From: [Simmons, Katrina E \(DFW\)](#)
To: [NC-Review](#)
Cc: [Johnston, Taylor \(DFW\)](#); [Richards, Marcus](#); [Verellen, Clayton](#); [Darveshi, Shaun](#); [Kieninger, David](#); [Sadia, Mosstafa](#); [SEPADesk2 \(DFW\)](#)
Subject: RE: DNS 24-033 Lake Lenore Shooting Range SEPA comments
Date: Friday, September 13, 2024 10:06:21 AM
Attachments: [image001.png](#)
[image002.png](#)

Subject: DNS 24-033 Lake Lenore Shooting Range SEPA comments

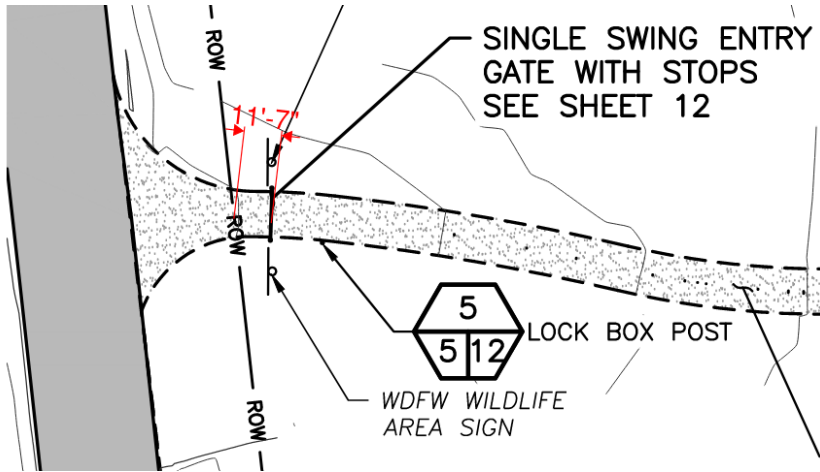
WSDOT Comment: The proposed gate needs to be outside the clear zone.

WDFW Response: The proposed gate is 11' 7" from the ROW. Here is a snip of the construction drawings and attached is the current set (not yet 100% complete and approved for construction). Does that distance meet WSDOT requirements?
